SWEETWATER LAKE DAM (7-10)

2023 Dam Safety Inspection Report
Brown County, IN | February 2024
Inspection Date: October 24, 2023

Burke Project No. 19.R230291.00000

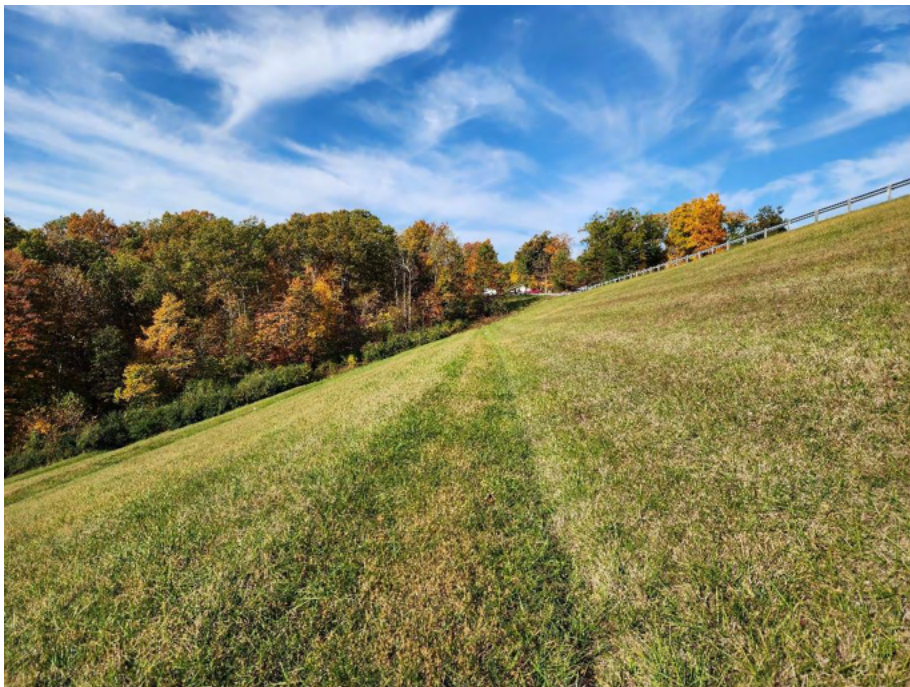
Top: Embankment crest from right side; note guardrail along edges

Bottom: Embankment crest from left side; note previously sealed transverse cracks
